43 Cholmeley Crescent, London N6 5EX (Planning Application Ref. HGY/2023/1684)

I am writing to object to the proposals for a garden studio as part of the current planning application for:

Figure 1 – Plan and Aerial photograph showing the proximity of the proposed studio to the rear garden of 12 Kingsley Place

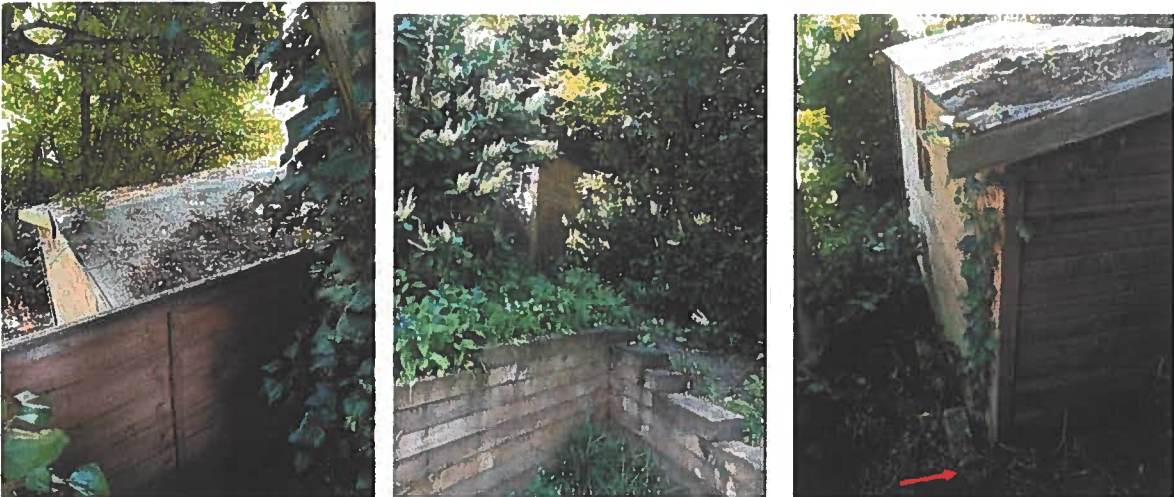
From the aerial photograph of the site and surrounding area (see Figure 1 in the Appendix to this letter), there do not appear to be similar structures of this size in the rear gardens of other properties

on Cholmeley Crescent and it is considered that the erection of a garden studio of this size will impact on the appearance of this part of the Highgate Conservation Area.

Figure 2 – Photo showing proximity of current shed to the boundary fence with 12 Kingsley Place

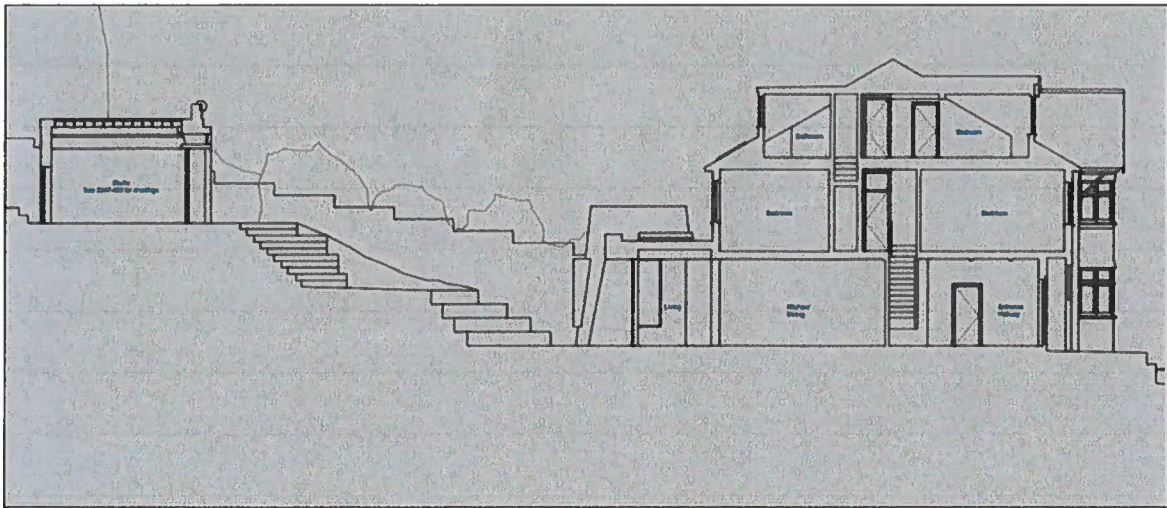
There is currently a small wooden shed within the rear garden of number 43 Cholmeley Crescent, which abuts the fence to the garden of number 12 Kingsley Place. The location of the existing shed is shown on the existing ground floor plan (drawing no. 2247-100), and the photographs at the Appendix of this letter also demonstrate how close it is to the boundary fence.

Figure 3 – Section showing the level change across the site, and the height of the proposed studio

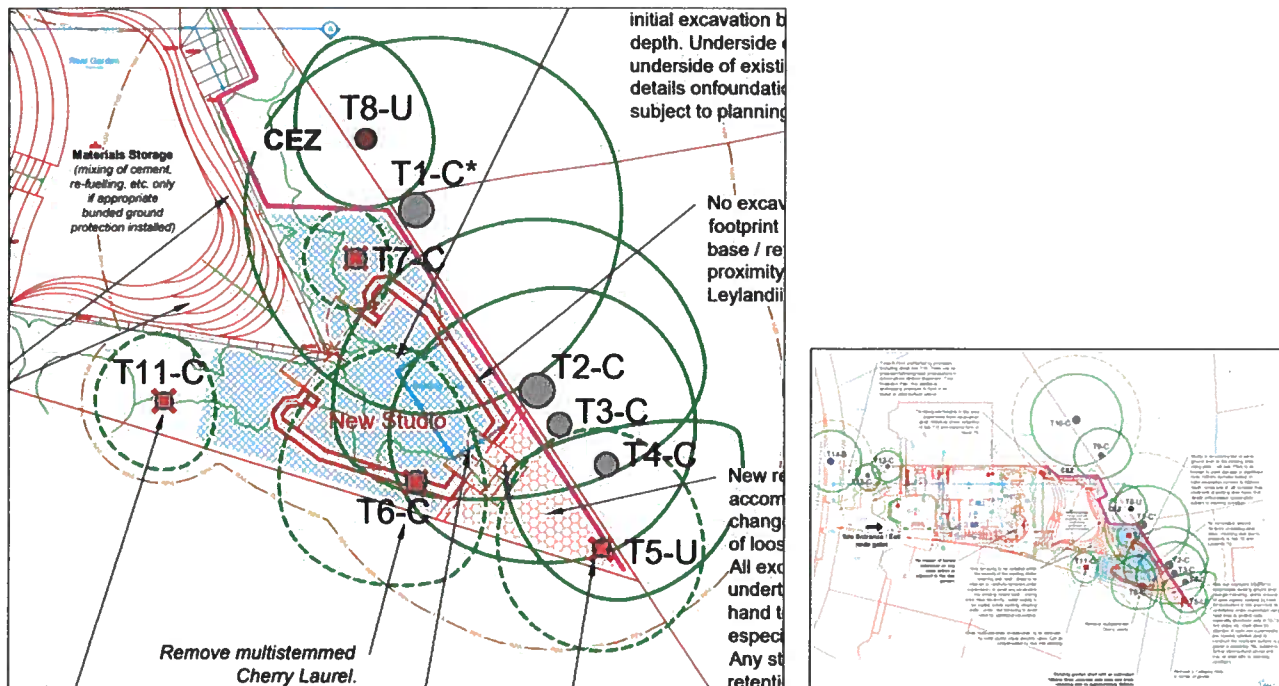
The existing side elevation (drawing no. 2247-202) demonstrates the level change across the site, as the height increases towards the boundary with properties on Kingsley Place. The proposed Section AA (drawing no. 2247-2350) clearly demonstrates the height of the top of the studio, which is the equivalent of two and a half storeys of the existing house, due to the ground level at this location (please see Figure 3 in the Appendix). Due to the site levels at the north of the garden, the studio will appear much taller than the elevations suggest and will be very visible from the properties and rear gardens of 12 and 13 Kingsley Place.

Whilst in Spring and Summer the existing trees will provide some screening, during winter there will be direct views through to the studio from 12 Kingsley Place.

Figure 4: Extract from Tree Survey, demonstrating the extent of the RPA and Canopy of existing trees

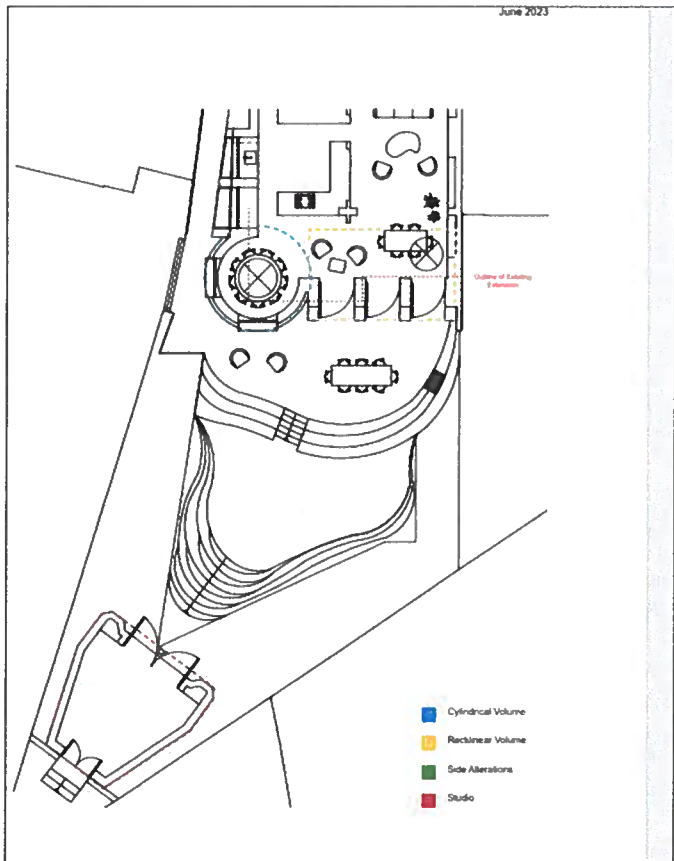
The Draft Tree Protection Plan demonstrates the proximity of trees T1-C*, T2-C, T3-C and T4-C to the boundary and that the proposed new studio falls within the root protection area of these trees and the proposed trees to be removed (T11-C, T6-C and T5-U) – please see extract at Figure 4 of the Appendix). Paragraph 3.5.4 of the Arboricultural Impact Assessment suggests that the proposed footprint of the new garden studio will impact on up to 20% of the RPA of any individual retained tree, but given the age of these trees, it could be greater.

The canopy of these trees also overlaps the new studio. I also have concerns that construction works could damage the roots of these trees. As noted above, these trees are outside of the application boundary and are not owned by the applicant. Any works suggested in the Tree Report (for example crown lift up to 4m for trees T2, T3 and T4 and periodic pruning (paragraph 3.4.2 of the Arboricultural Impact Assessment) would require permission from third parties.

Paragraph 3.5.5 of the Arboricultural Impact Assessment) also notes that *"the finalised design of the proposed studio foundation slab must make allowance for the presence of the roots of trees T1-T4 and ensuring that conditions are favourable for their survival including access to moisture and gaseous exchange."* I therefore consider that further consideration should be given to locating any structure in the proposed location.
